ITEM 4.3. CENTRAL TO EVELEIGH UPDATE - URBANGROWTH NSW

MEMORANDUM BY THE CHIEF EXECUTIVE OFFICER

Figure 1: Central to Eveleigh Study Area marked in the blue line. Within the Study Area individual precincts of government-owned land are coloured orange.

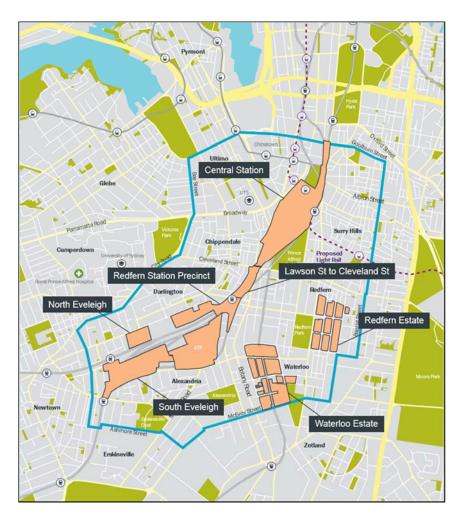
The map in Figure 1 produced and published by UrbanGrowth defines a Study Area covering 560 hectares within the Sydney LGA. It clearly identifies the precincts of government-owned land which will be the focus of the forthcoming Urban Transformation Strategy.

What is not clear is how many, if any, other yet to be identified government-owned sites within the study area are being considered for renewal and how much privately-owned land currently within the *Sydney Local Environmental Plan 2012* may be identified for rezoning to increase the scale and density of development.

The study area boundary (shown above) is Crown Street, Surry Hills to Goulburn Street, along Goulburn Street through the southern part of the CBD to Harris Street and Wentworth Park, and takes in all of Ultimo, Chippendale, Darlington to Newtown and then to Ashmore street in Erskineville, through to McEvoy Street and along Phillip Street and back to Crown Street. It includes a number of conservation areas including but not limited to parts of Redfern, Surry Hills, Chippendale and Alexandria.

One of the issues arising, is the message this boundary signals to developers and land owners, let alone the residents and broader community that live and work within the boundary.
